CITY OF ALBUQUERQUE

Re: Sts. Peter & Paul Church School, 5800 Ouray Rd NW
Request for Certificate of Occupancy- Transportation Development
Architect's Stamp dated 07-08-15 (H11-D062)
Certification dated 01-17-17

ARCHITECTURAL SITE PLAN

AS102

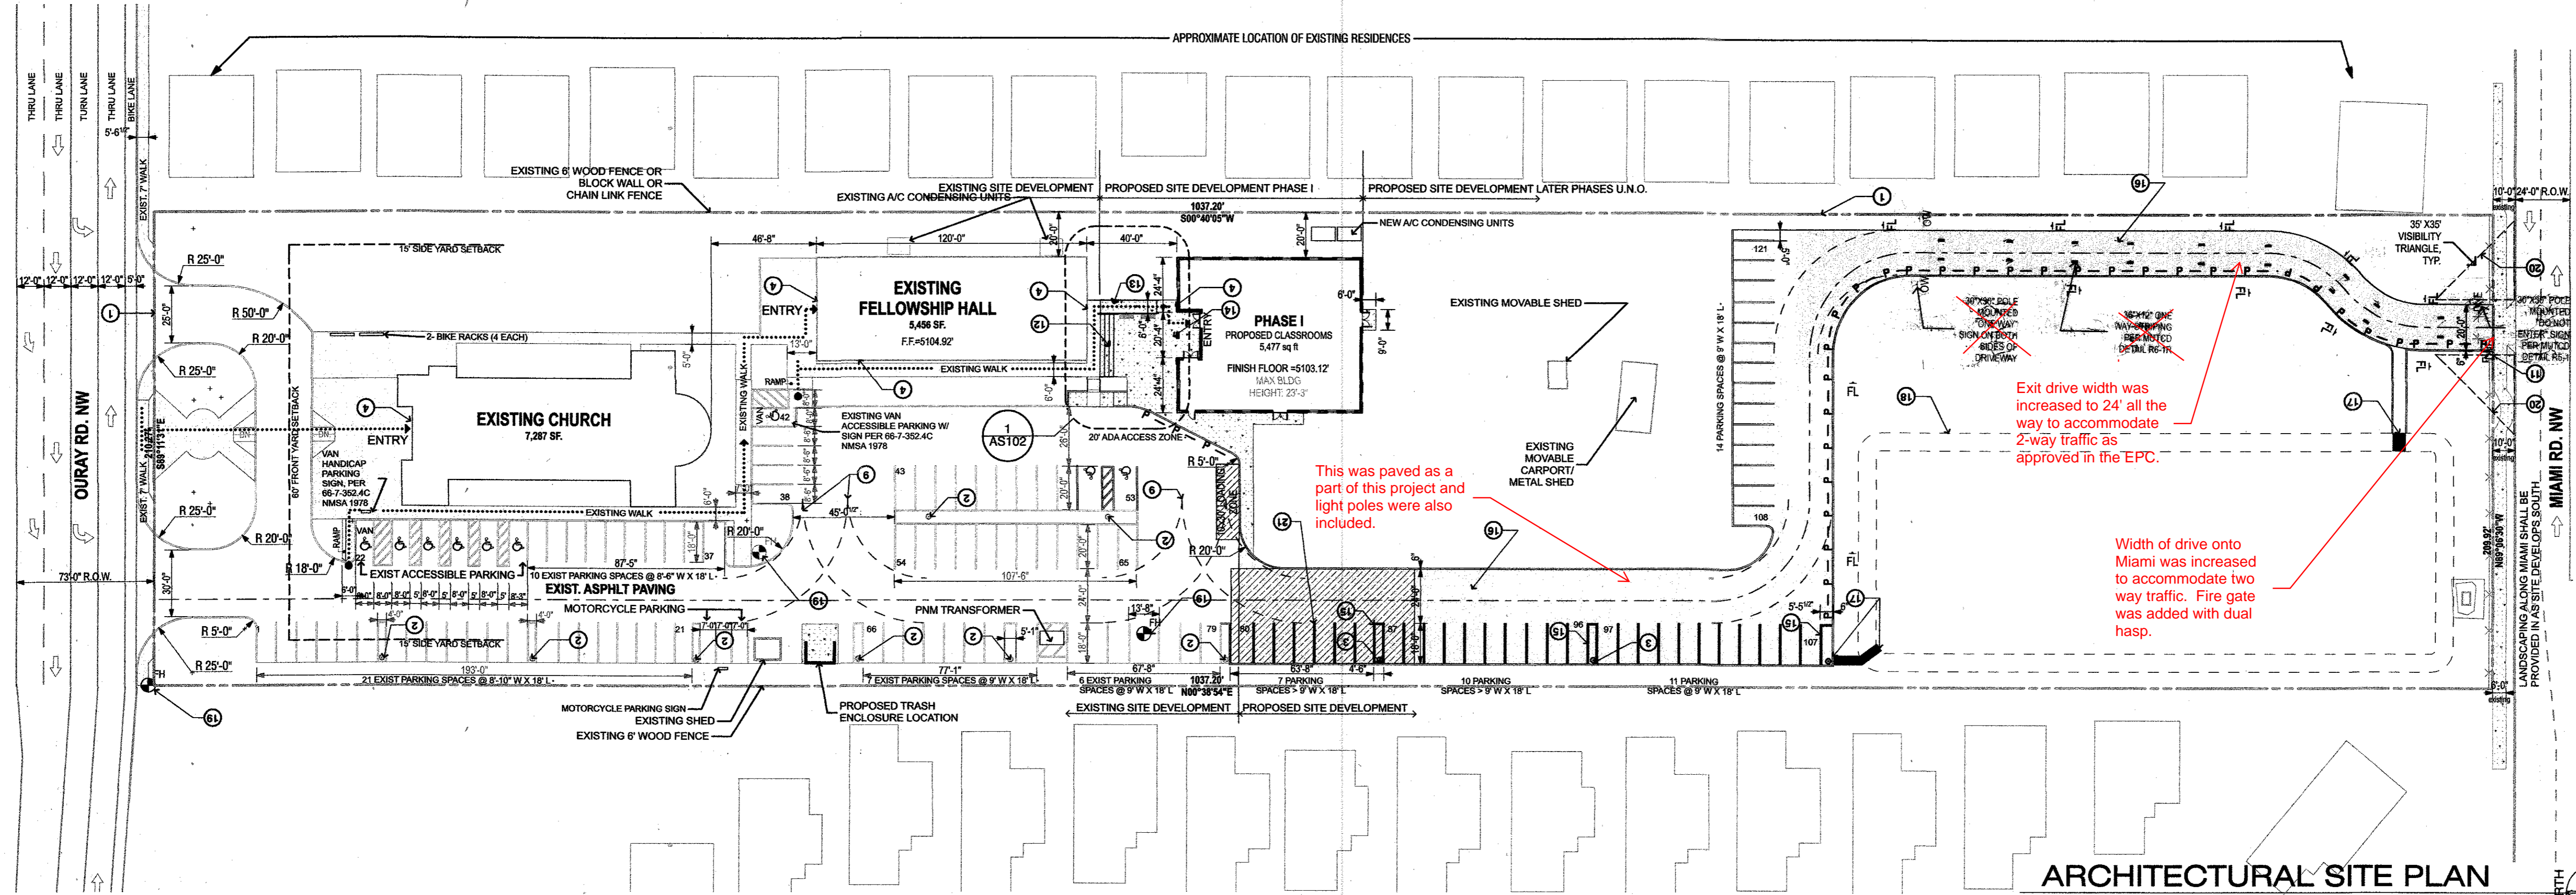
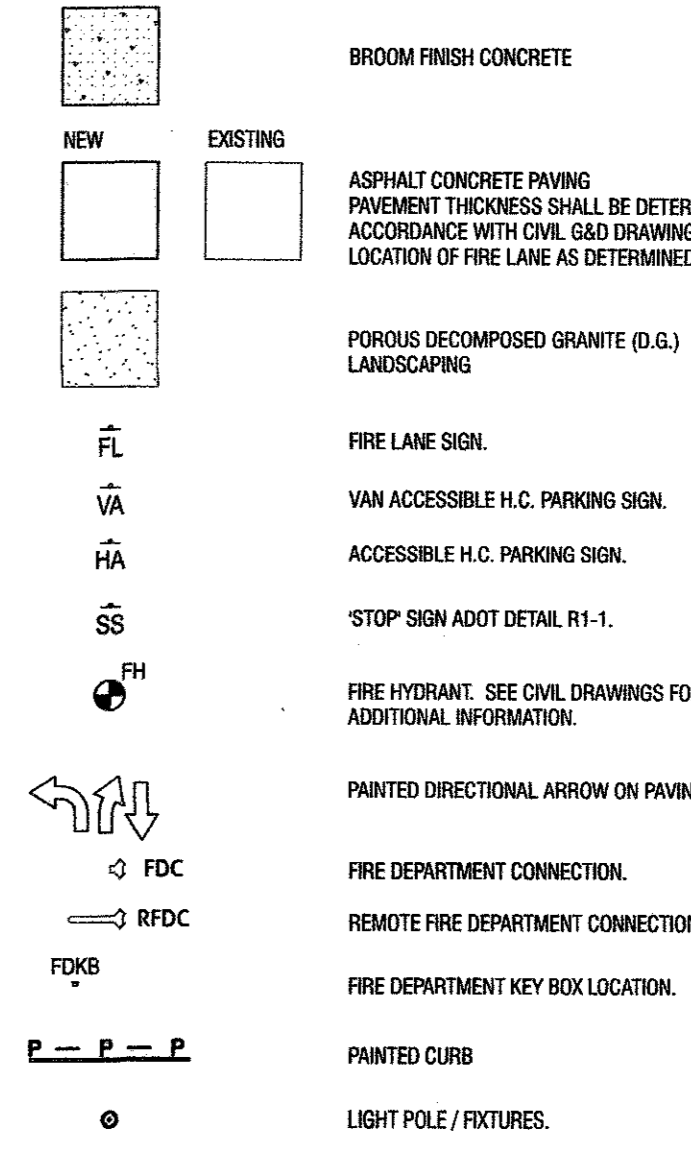
- Property Line.
- Existing pole-mounted light fixtures (typical). *Poles added as part of this project*
- Future 16' high pole-mounted light fixtures to match existing (typical) at 10' a.f.f. away from residential side of buildings only.

- Concrete-paved Entry plaza.
- 6" high concrete curb around light pole.
- Exit Drive to be paved prior to the commencement of any Phase II Construction. *Exit drive was paved all the way out to Miami*

As-built transportation revisions shown in red

Based upon the information provided in your submittal received 01-20-17, Transportation Development has no objection to the issuance of a Permanent Certificate of Occupancy. This letter serves as a "green tag" from Transportation Development for a Permanent Certificate of Occupancy to be issued by the Building and Safety Division.
